Agenda  
Village of Glen Ellyn  
Special Meeting  
Monday, December 18, 2017  
7:00 PM  
Glen Ellyn Civic Center, Room 301

**H. Taylor Avenue Pedestrian Tunnel Project (Professional Engineer Daubert) (Trustee Kenwood)**

**1. Motion to increase the appropriation for Phase II engineering services associated with the Taylor Avenue Pedestrian Tunnel Project provided by Alfred Benesch & Company in the amount of \$34,105 for a revised total appropriation of \$189,565 to be expensed to the Capital Projects Fund. 2. Motion to authorize the Village Manager to execute Change Order No. 2 to the Phase II engineering services agreement with Alfred Benesch & Company for the Taylor Avenue Pedestrian Tunnel Project for additional investigations and analyses in the amount of \$34,105 resulting in a revised total fixed price of \$189,565.**

**From:** O'Connor, Michael  
**To:** [Richard Daubert](#)  
**Cc:** [Keaschall, Andrew](#)  
**Subject:** Village of Glen Ellyn Taylor Ave. - Supplement to Address New Conditions  
**Date:** Thursday, December 07, 2017 10:13:06 AM  
**Attachments:** [10507 - Glen Ellyn Scope Change Spreadsheet.pdf](#)  
[Glen Ellyn Scope Change Attachment Exhibits.pdf](#)  
[

**TAYLOR AVENUE BIKE / PEDESTRIAN TUNNEL**

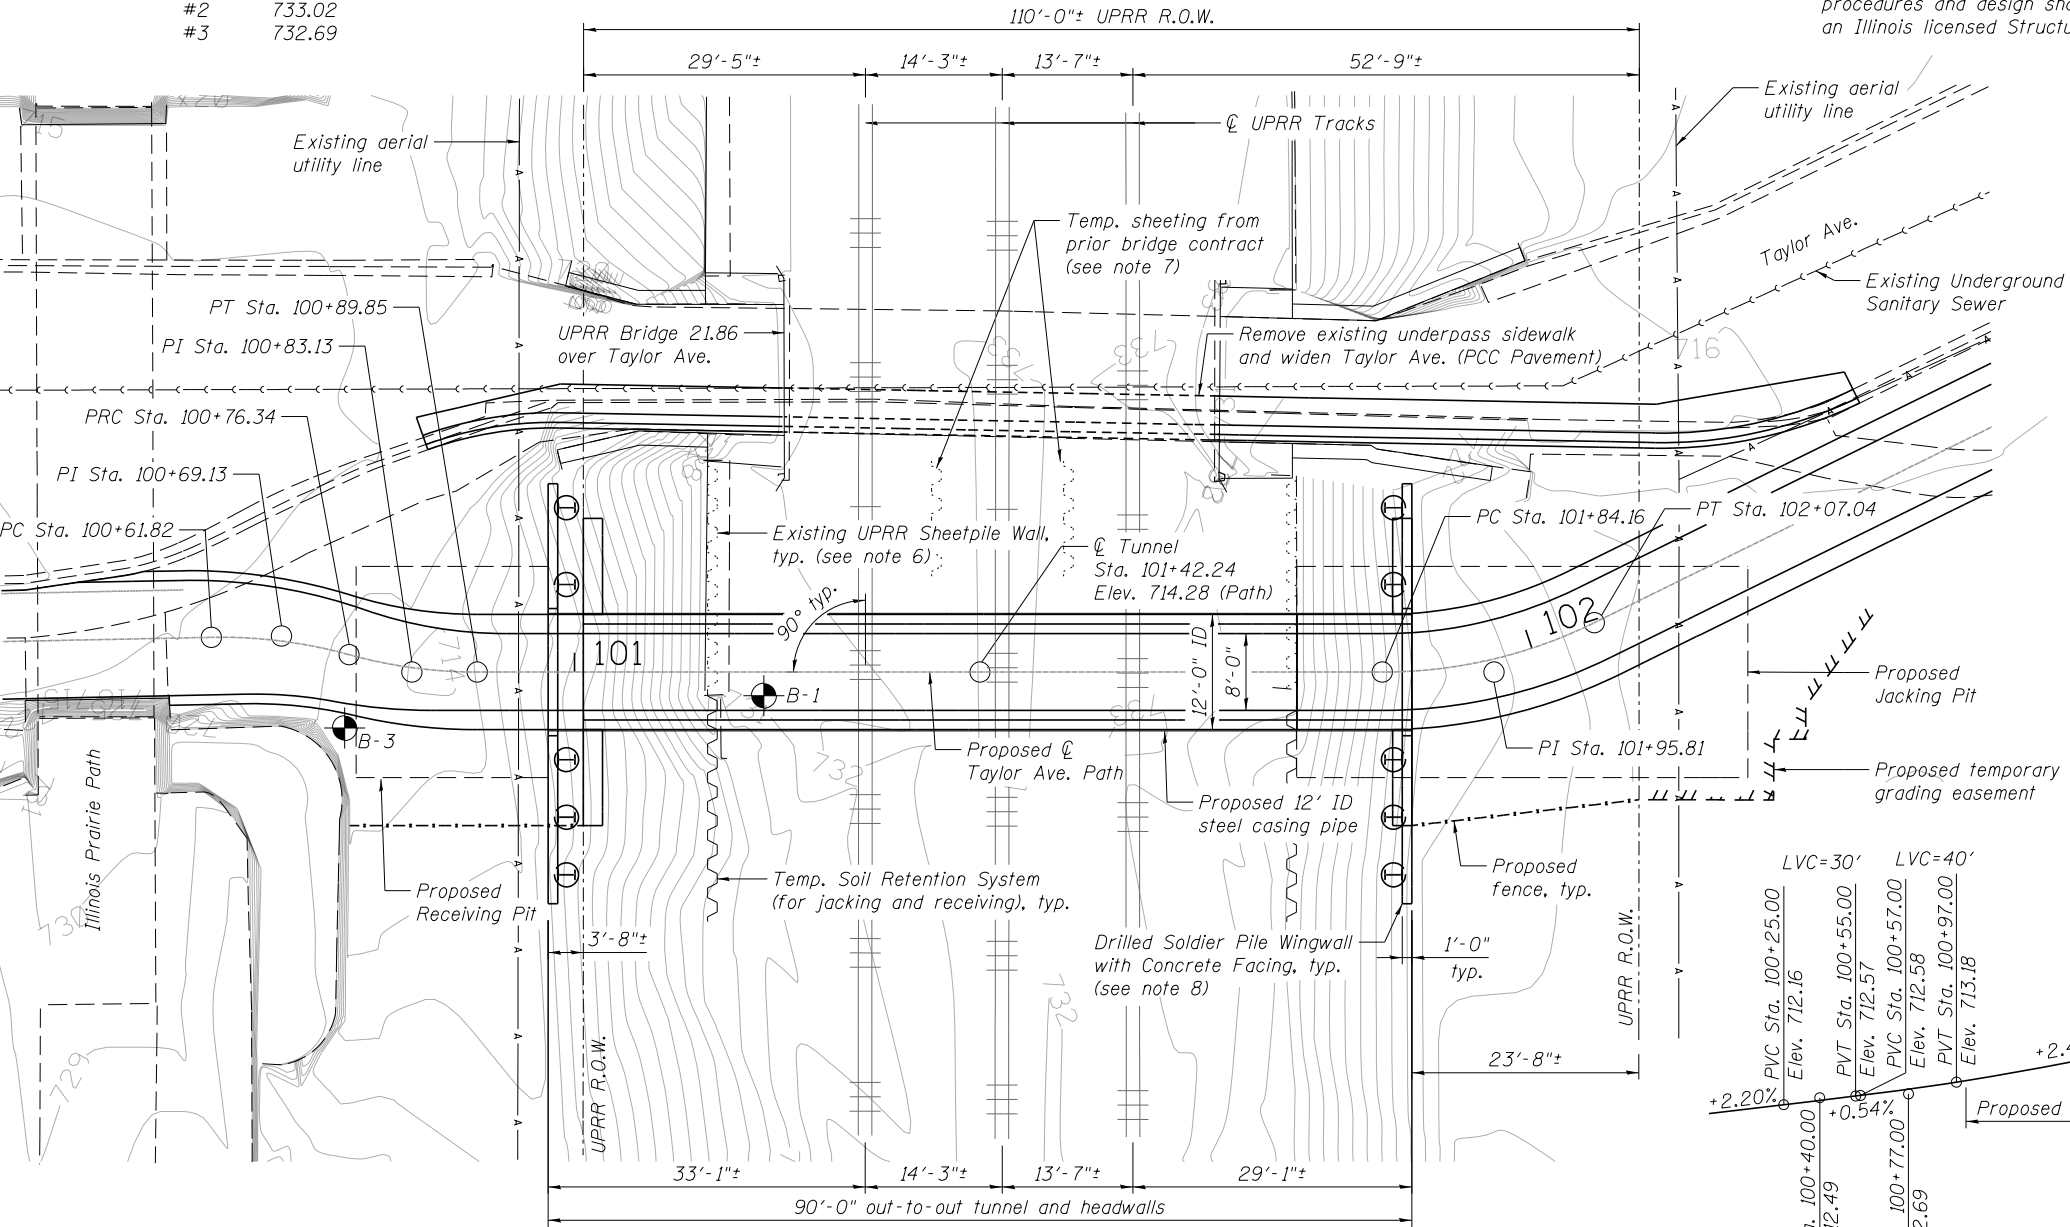
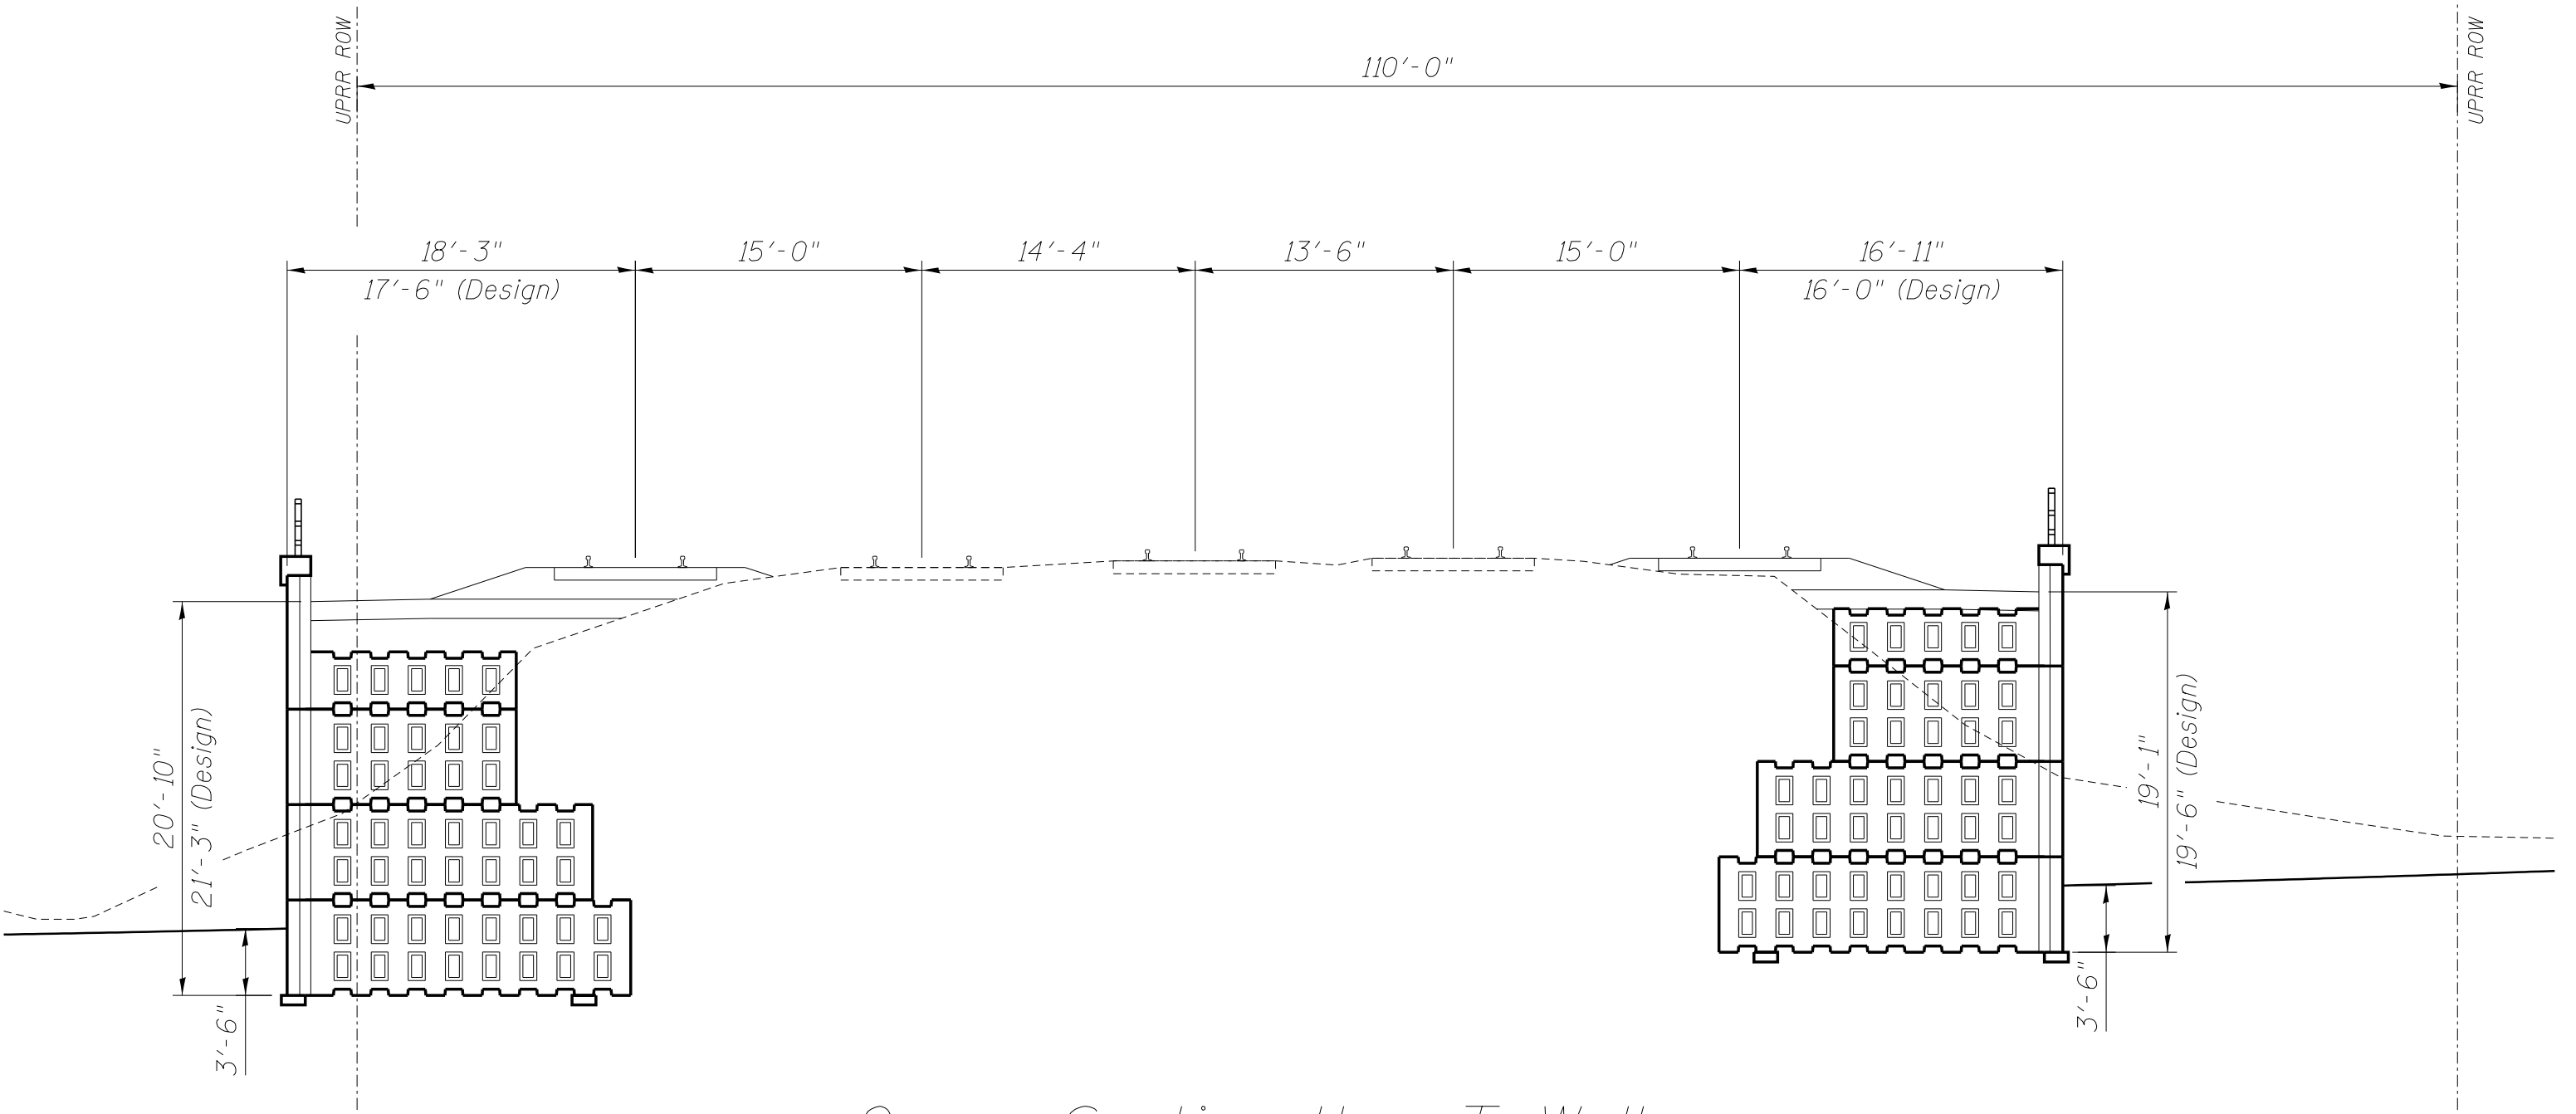
- 1) Development of retaining wall plans to support future track loading for UPRR:
  - a. Scope included design of walls to accommodate three tracks and associated embankment as shown on Exhibit 1.

- b. UP required design of precast modular walls to accommodate rail loading for future condition with 5 tracks. UPRR Review Response: The design should support a future track on each side of the existing track with 15 ft. track centers. The design shall also support the loading of these future tracks as well as the required grading. See Exhibit 2.<sup>1</sup>

Exhibit 3

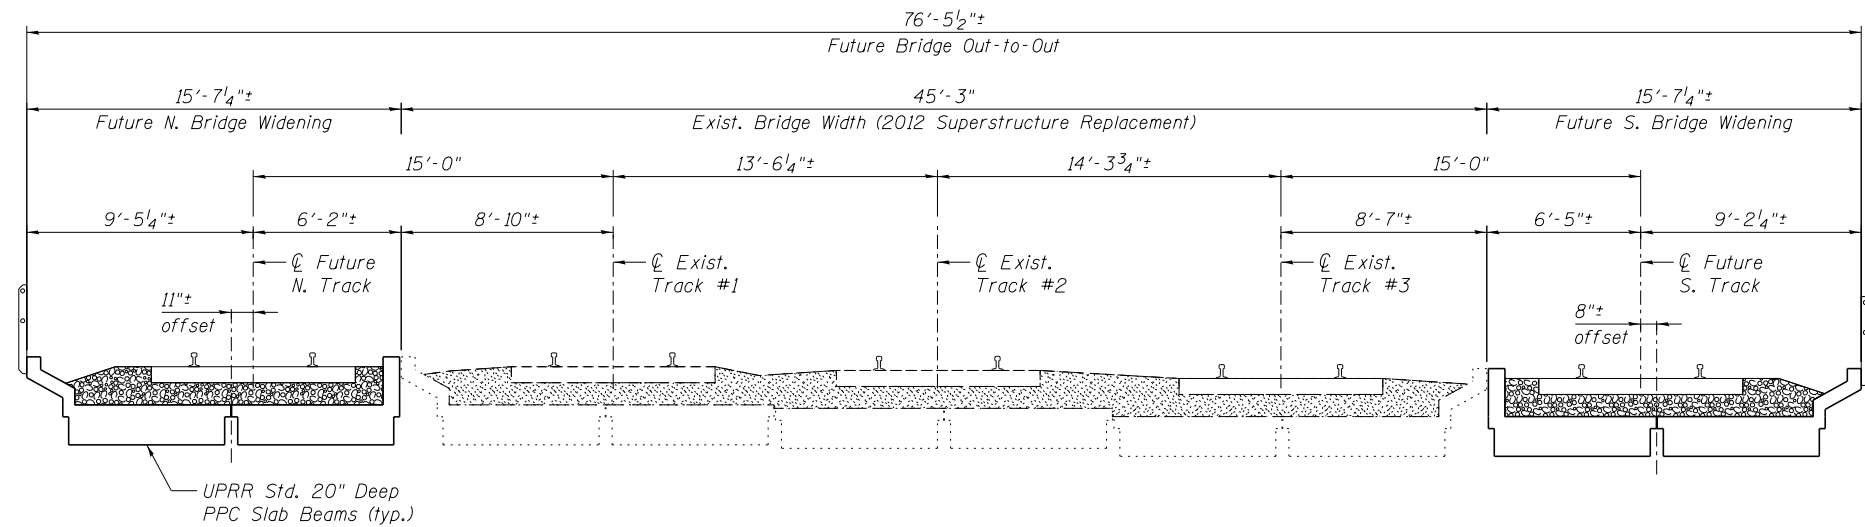
- 2) Full Calculation development for Temporary Earth Retention Systems:
  - a. Scope does not include full calculations for earth retention systems as the Contractor is responsible for that design per IDOT Standard Specifications 522.07: *The temporary soil retention system shall be designed by the Contractor as a minimum, to retain the exposed surface area specified on the plans or the exposed surface area needed by the Contractor to complete the work.*

- b. UP required full calculations and detailing of plans by tunnel designer in order to get approval of final plans, per 60% Plan Comment Review. See Exhibit 3. UPRR 7/25/2017 Review Response: Calculations for the temporary shoring system will need to be submitted for review. It is acceptable for the final shoring system submittal to come from the Contractor, however, adequate calculations for the proposed system need to be submitted by the designer to prove that the shoring system will work and meet UPRR horizontal and vertical movement criteria.<sup>1</sup>

**FUTURE BRIDGE CROSS SECTION**  
(Looking East)

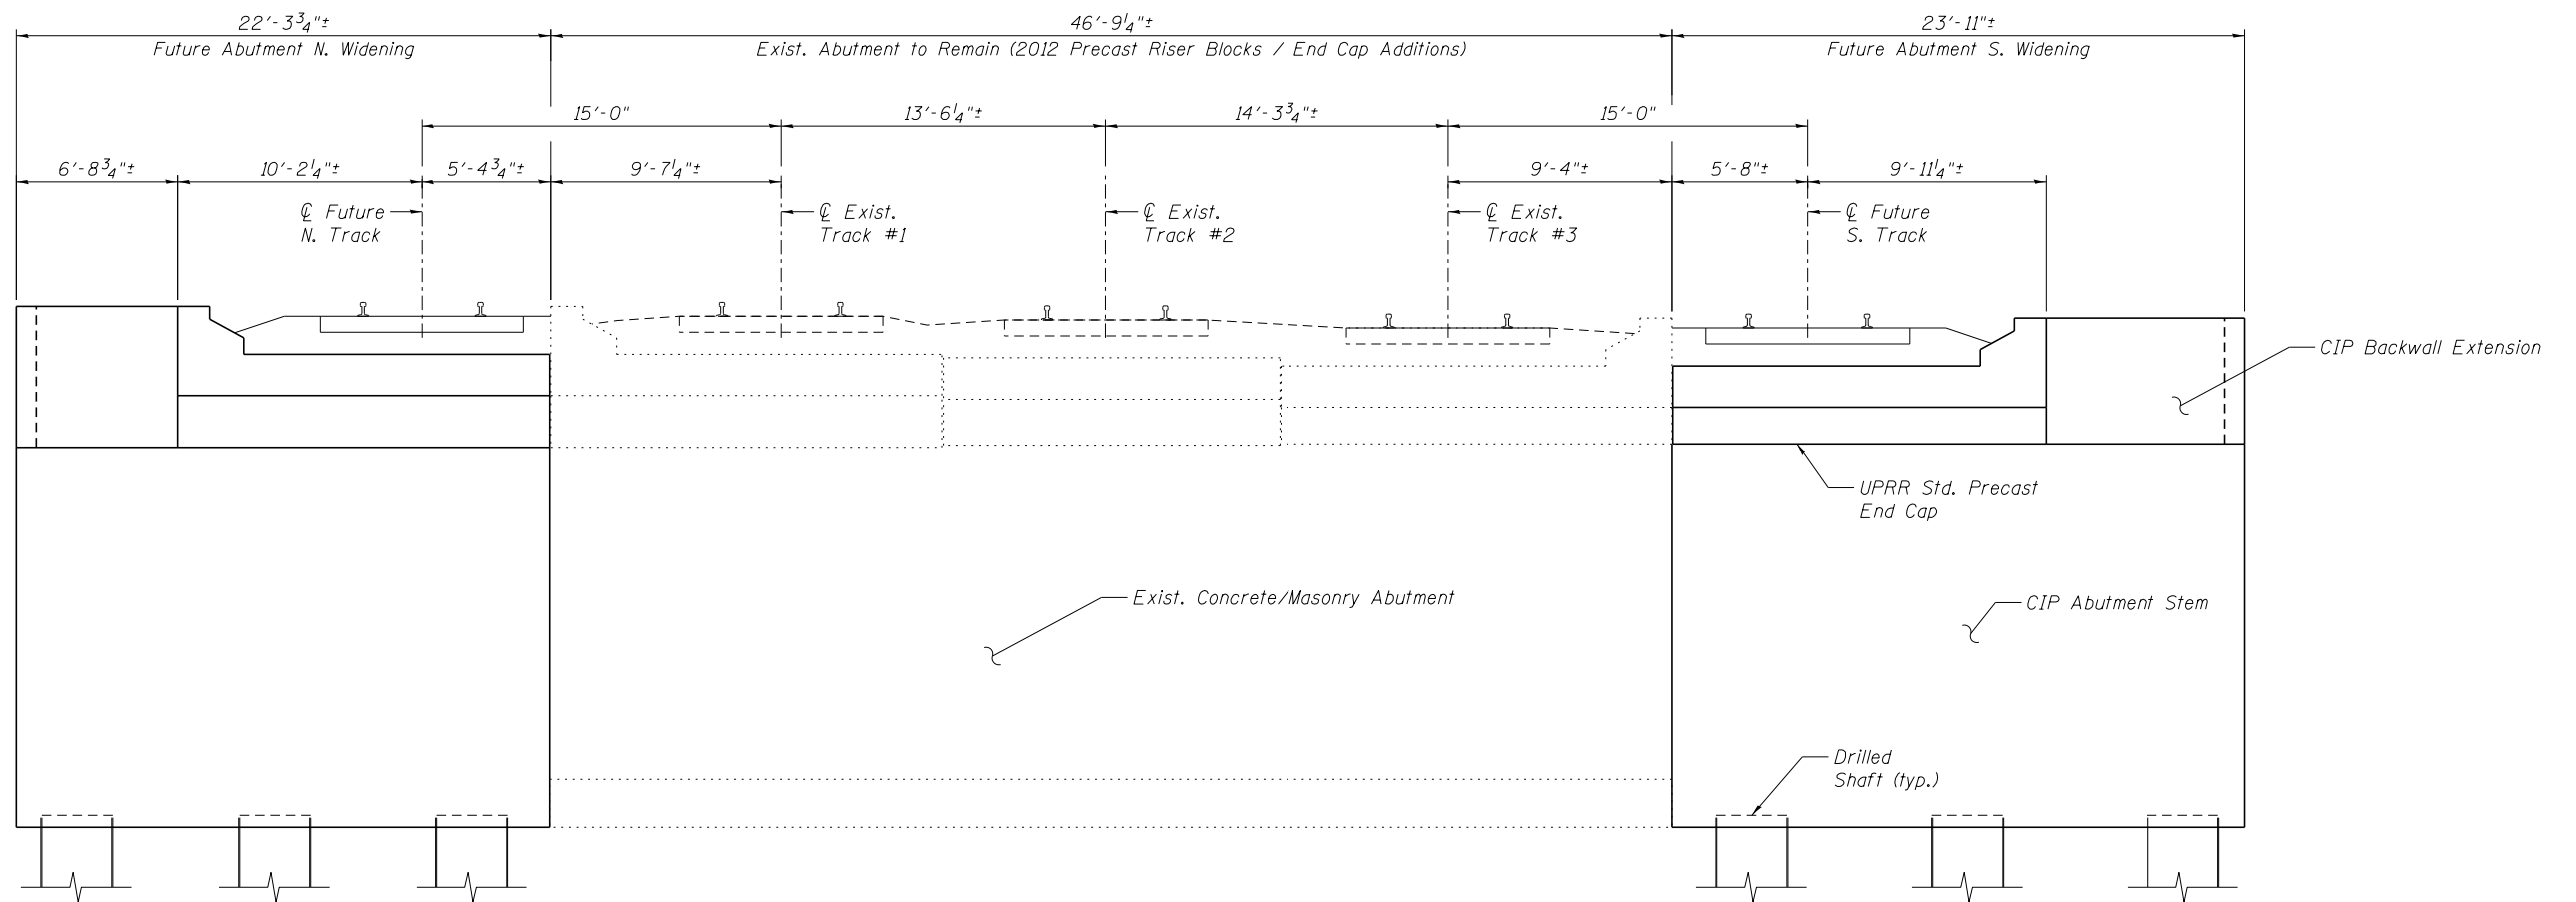
**Sheet 1: Future Bridge Cross Section and Abutment Elevation**

- This sheet includes concepts for both bridge superstructure widening and bridge abutment widening to support 1 new track on each side at 15'-0" centers.
- The bridge superstructure widening depicts similar UPRR standard 20" deep PPC slabs as were used in the 2012 superstructure replacement project.
- The abutment widening assumes a new drilled shaft supported rectangular CIP concrete stem wall with UPRR standard precast end caps (also used in the 2012 superstructure replacement project).
